## **MODIFICATION REPORT: SSD-10470**

### **APPROVED WAREHOUSE AND DISTRIBUTION CENTRE**

**11 & 13 Percy Street, Auburn  
LOT 1 & 2 DP 1183821**

**Section 4.55(1A) Modification – SSD-10470 (MOD 1)**

## **Figure 5. Ground Floor Plan** (Source: Nettleton Tribe, 2021)

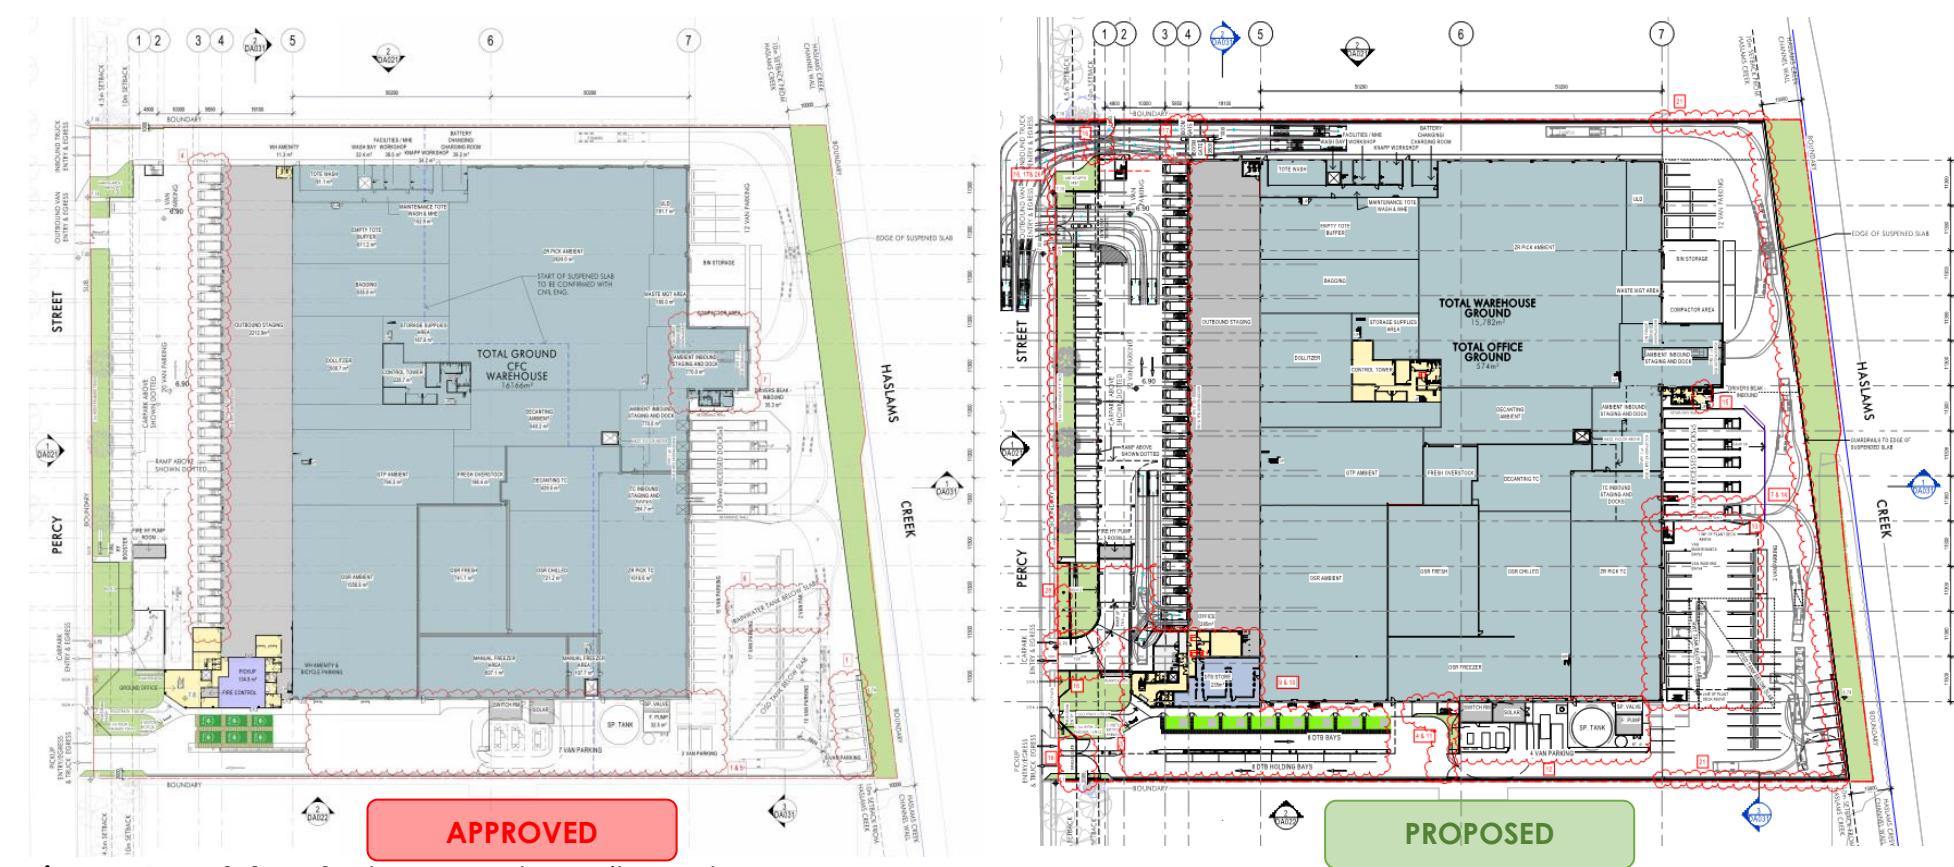
The first mezzanine includes the provision of:

- Sequencing conveyors
- Empty tote buffer area
- Control tower

The warehouse level 1 (including second mezzanine) includes the provision of:

- OSR shuttle areas – an automated material handling system by Knapp
- Goods to persons systems
- Production areas
- Manual pick racking

**Figure 8. Elevations Plans** (Source: Nettleton Tribe, 2021)

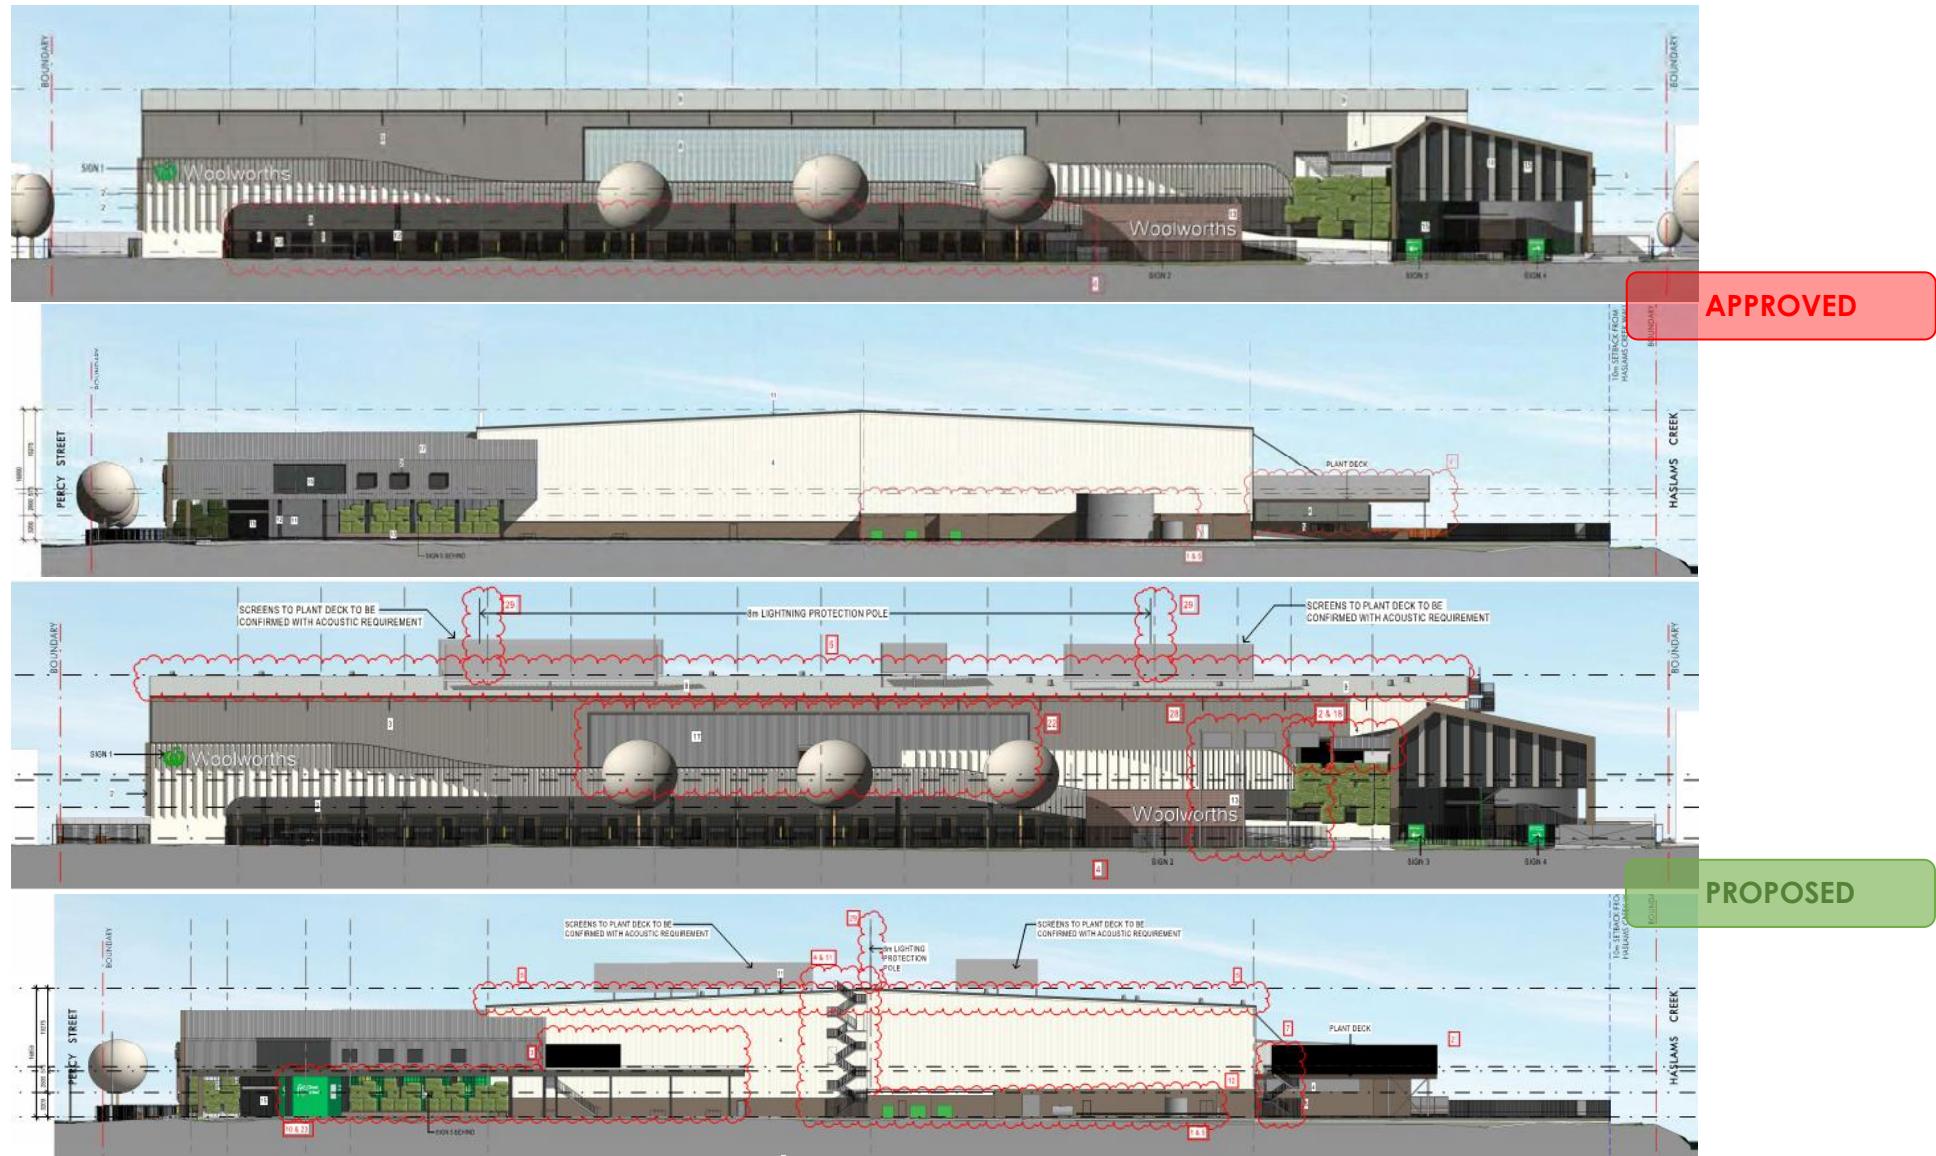
The proposal, as modified, would result in an increase of building height by 3.85m, which is attributed to plant areas only. The highest plant deck screen would extend to an RL of RL28.50.

The proposed building height is 20.7 m (at a maximum RL of RL28.5), to the top of the plant area.

Figure 14. Extract of proposed Southwest Elevation (Source: Nettleton Tribe, 2021)

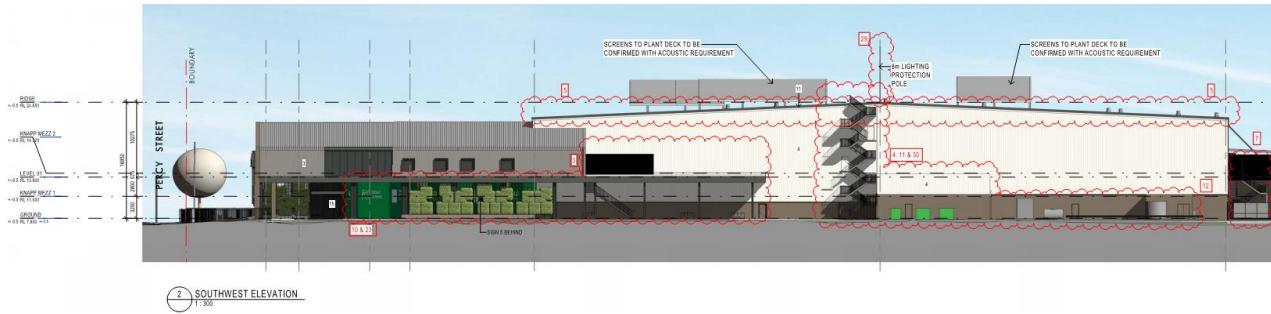
The proposed modifications do seek to include plant areas on the warehouse roof, which would be screened, and may extend to a maximum RL of RL28.5. Such plant areas have been typically located central to the approved building, limiting their presence from external onlookers.

As demonstrated in the above perspective images (Figure 10 and Figure 12), such plant areas would not be visible from the Percy Street level.
